BUILDING COMPLETION REPORT

NOTICE OF COMPLETION UNDER SECTION 187 (I) OF THE
CITY OF KARACHI MUNICIPAL ACT, 1933

FINAL.
PLAN SHOWING PROPOSED
ADD: & ALTERATION IN BUNGALOW
ON PLOT NO 173 J.M.I.
JAMSHED QUARTER.
SCALE = 8"=1'

With reference to your application dated 24-7-39,
with a plan for the proposed buildings/additions and alterations on plot
No. 64 Survey Sheet No. J.M.1, Jamshed Quarter,
I have to request you to comply with the following requirements—

PLAN SHOWING PROPOSED

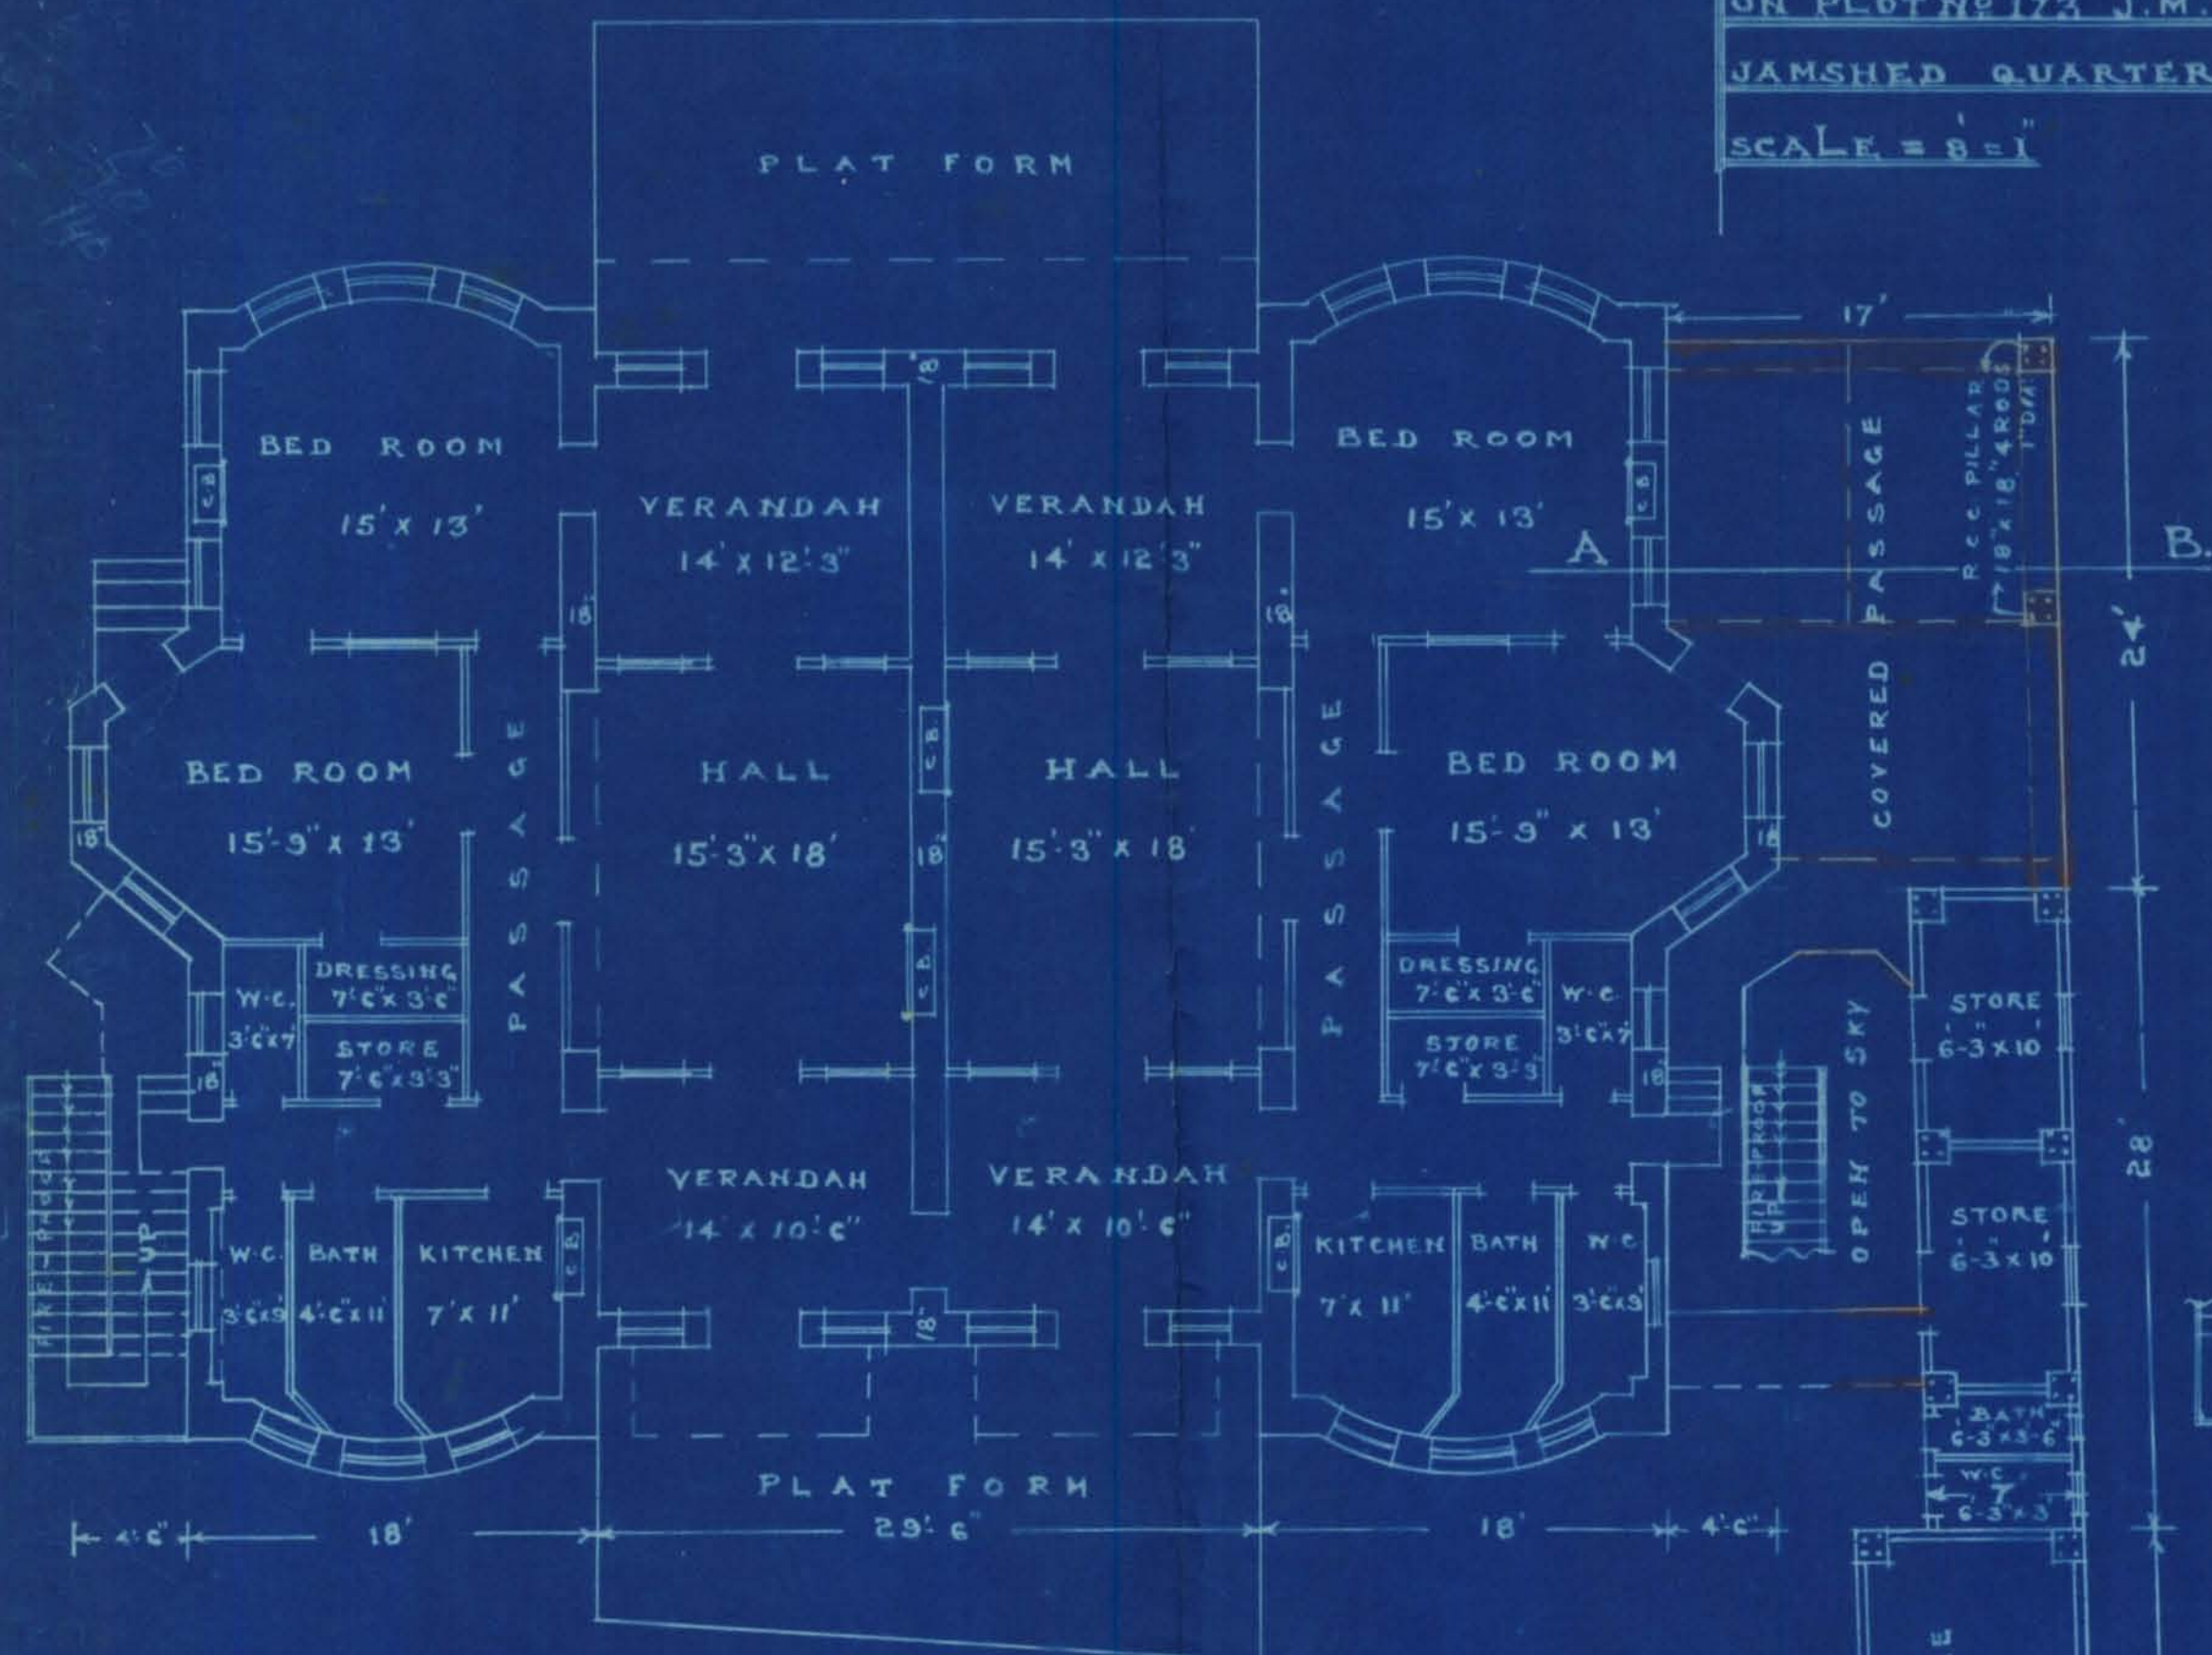
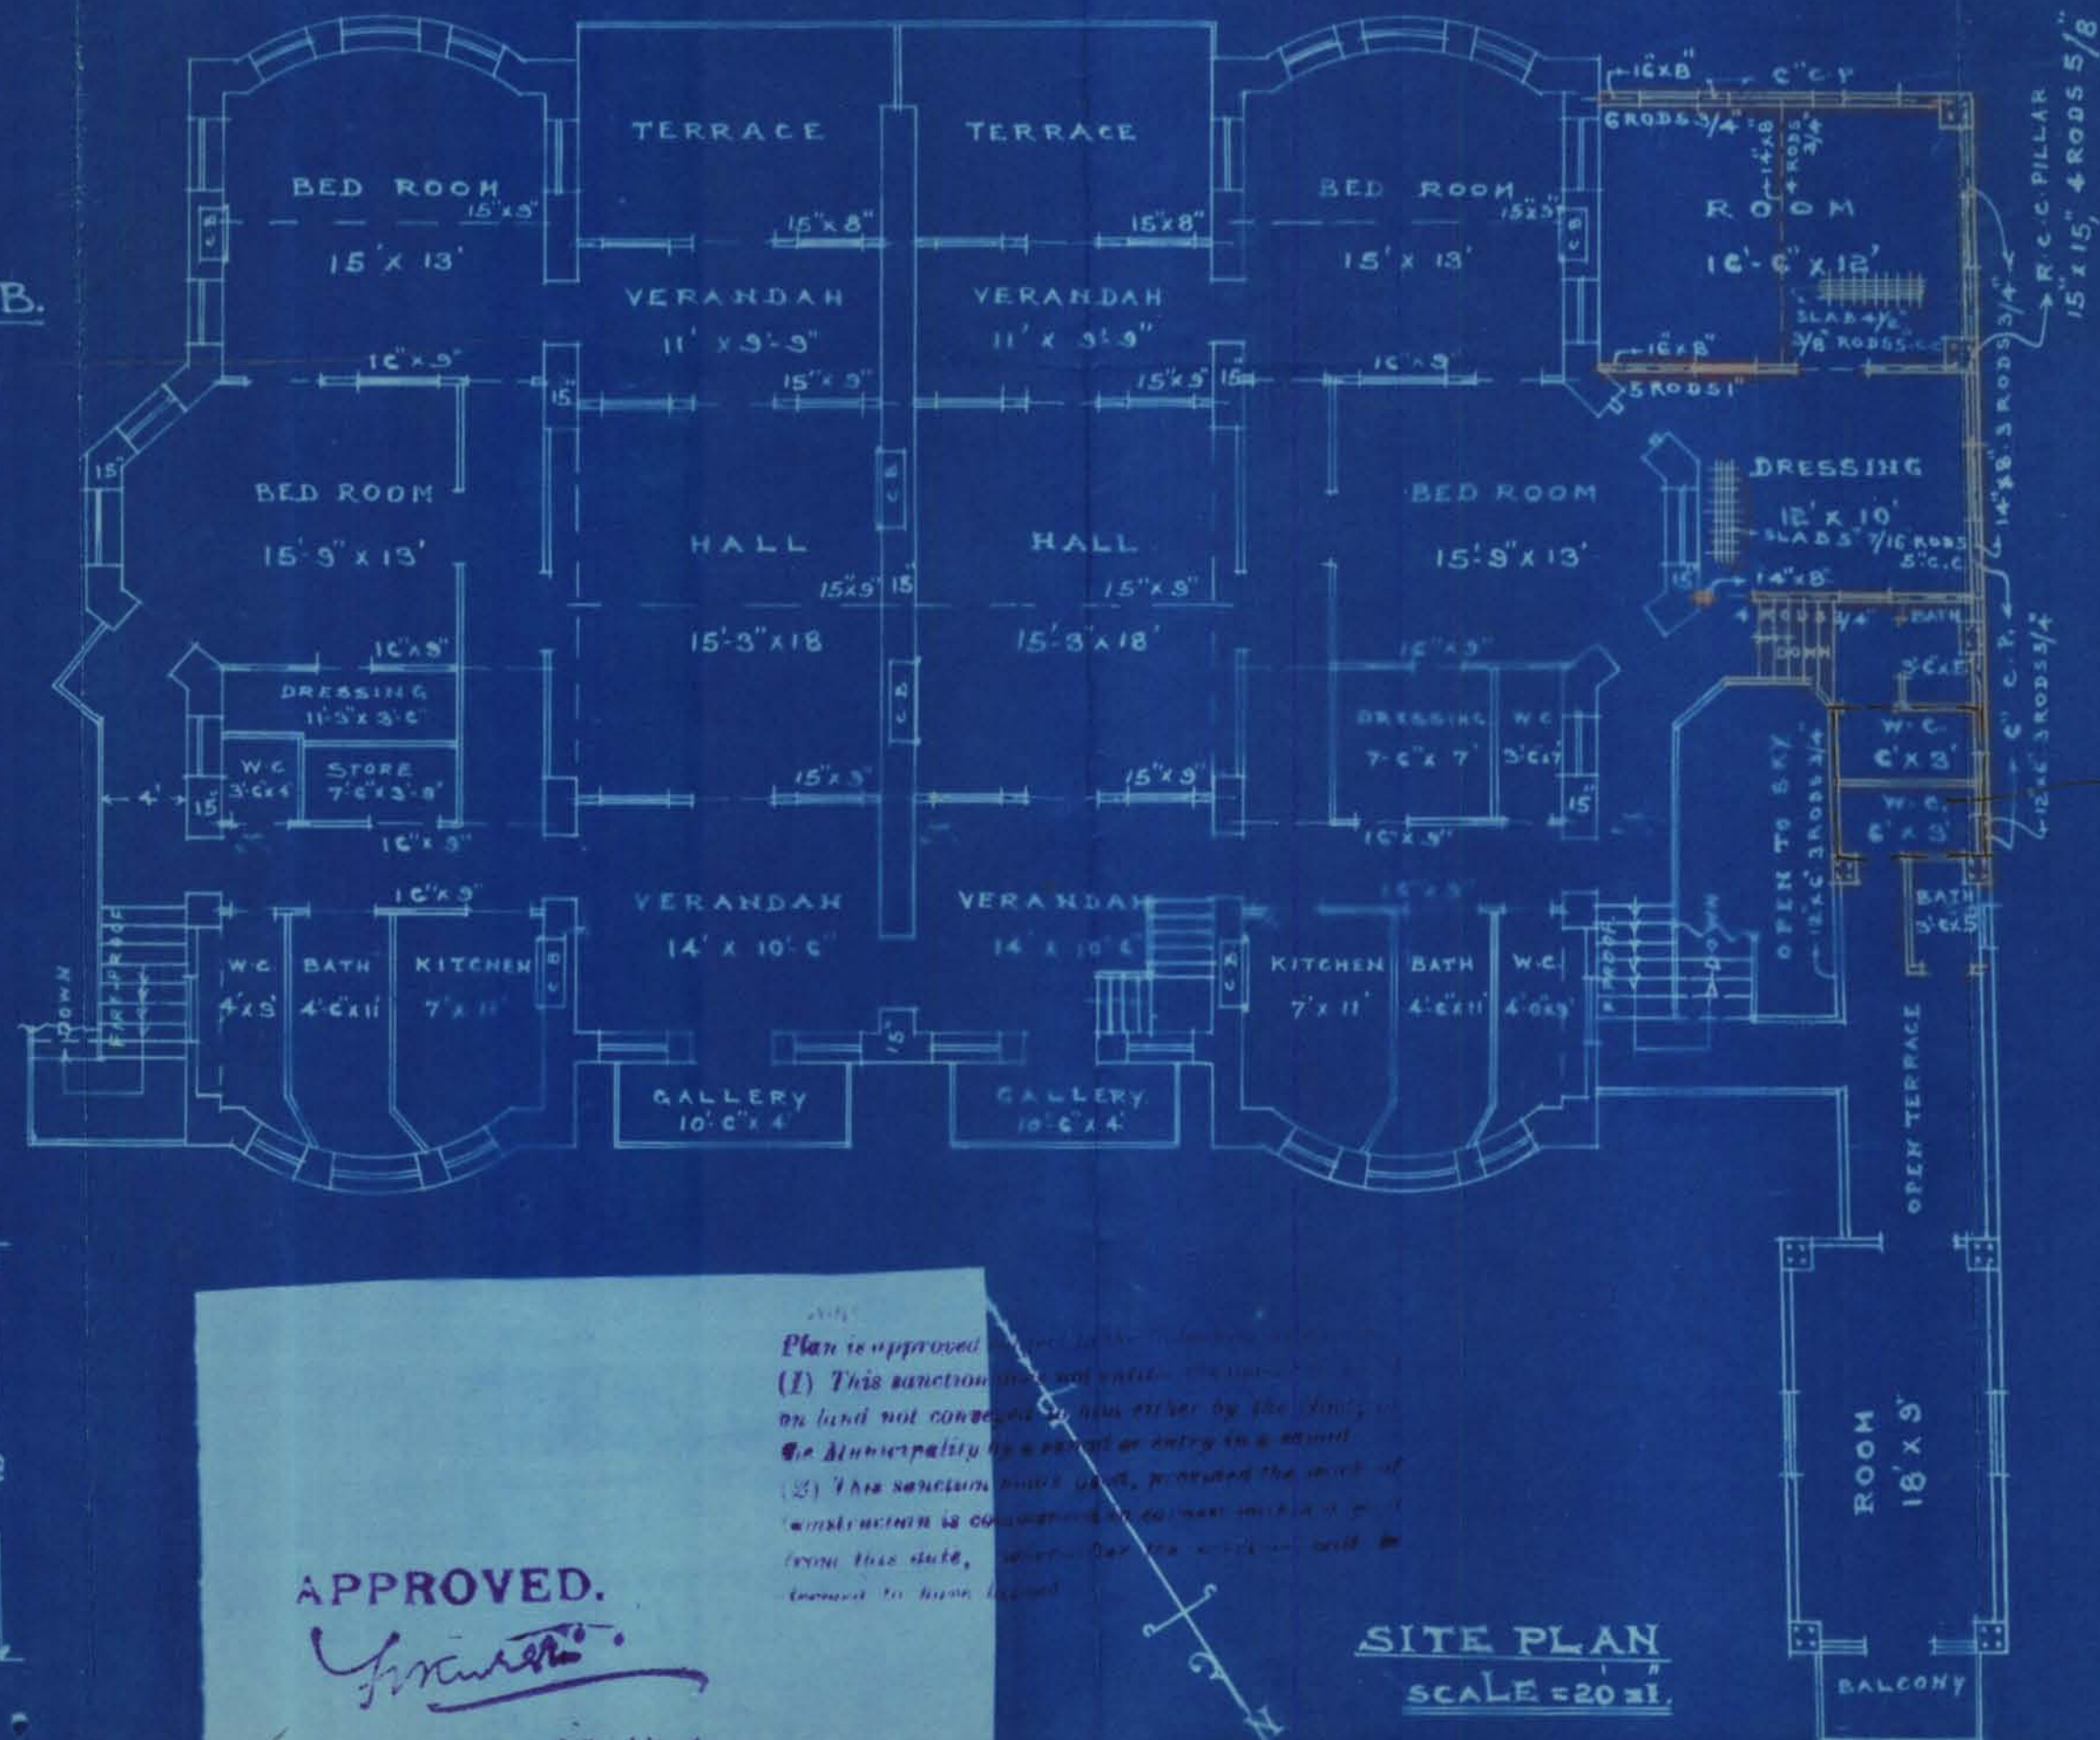
With reference to your building on plot No. 64 sheet
No. Jm 1, Jamshed, Quarter, I have to inform you that the
building as is being erected, or re-erected, differs from the approved
plan. You are therefore requested to make the building in
conformity with the approved plan on receipt hereof, failing which,
action will be taken under the Act which please note.

Deviation.

1. ask for amended plan

We are in receipt of your letter addressed to our client Mr. Hotchand Shewaram for additions & alterations on plot No. 64- J.M. I we beg to say that the alteration being ~~an~~ minor the same will be shown in the final plan which is shortly to be submitted for your approval. No action may therefore kindly be taken .
